Appendix 4.1b EIA Consultation Responses

Hagshaw Hill Repowering & Douglas West Extension

Please find attached a response from East Ayrshire Council on the Hagshaw Hill repowering proposal.

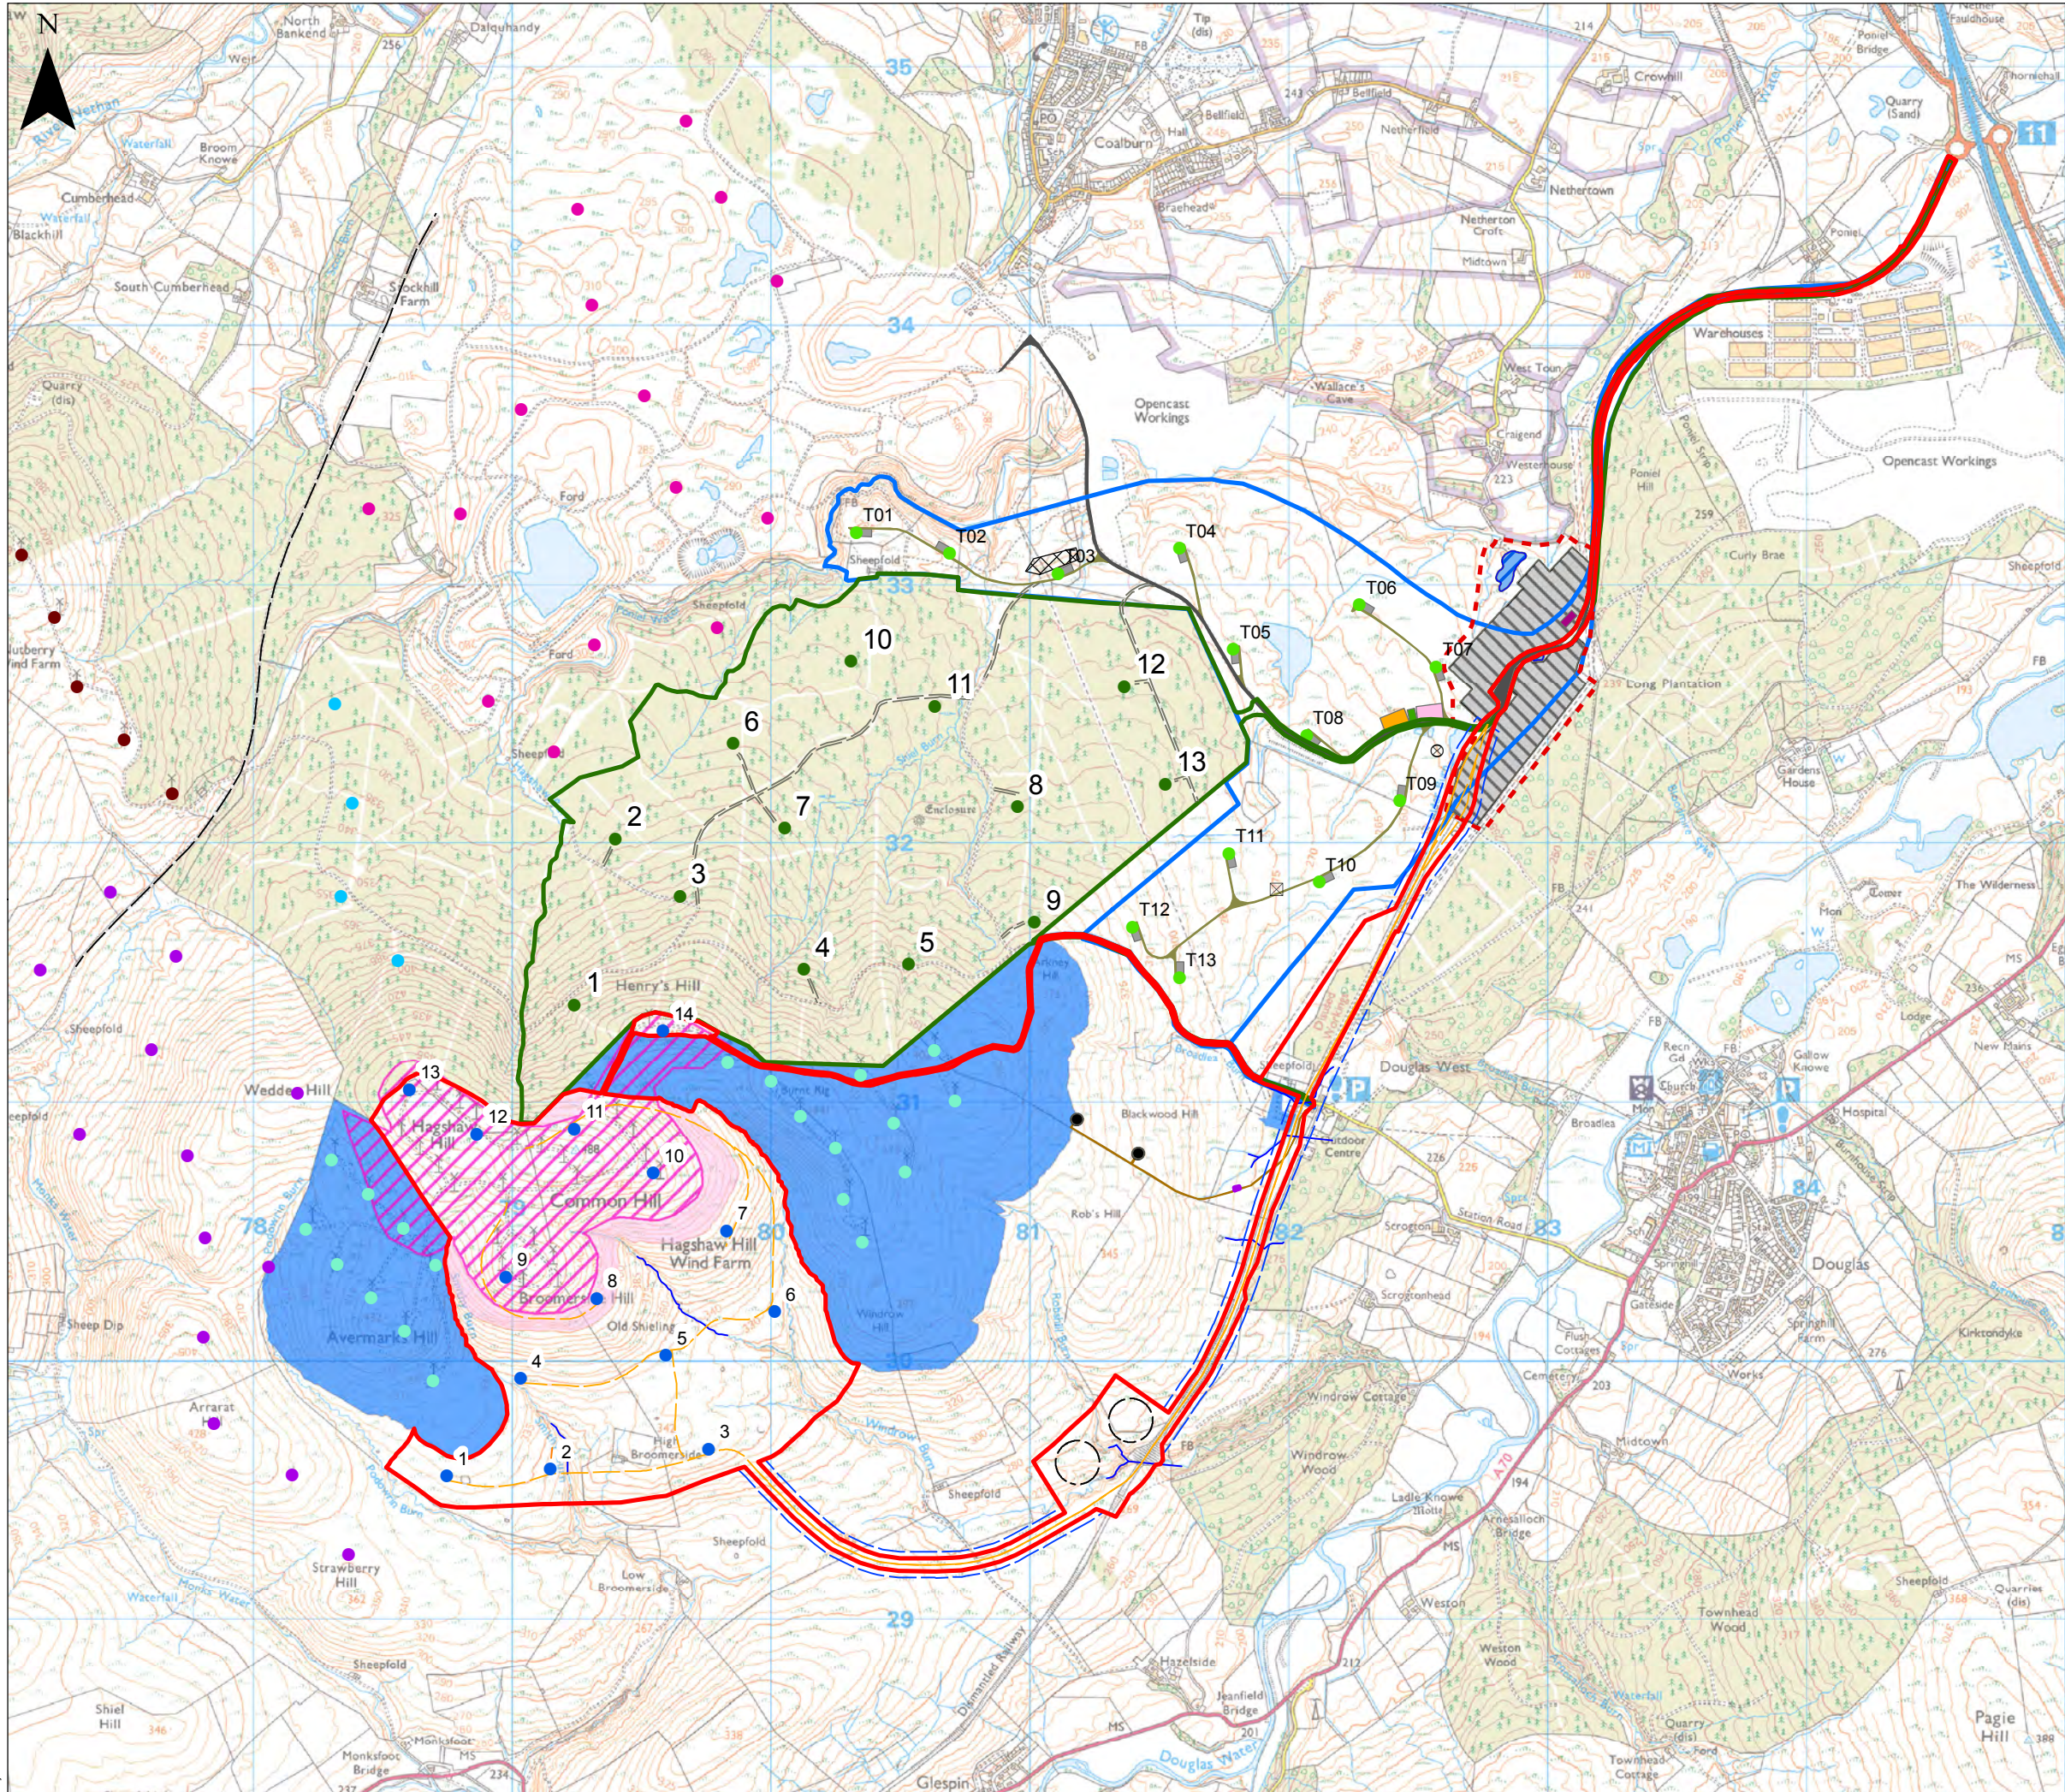
The proposed methodology states that in terms of cumulative impact the study will focus on schemes within 20 km of the application site, plus the Clyde grouping of turbines. Presumably for information, figure 3 has also been included which shows operational, consented and proposed wind farms within 35km. It is noted there are several developments not included on this map: Enoch Hill, South Kyle and High Park Extension.
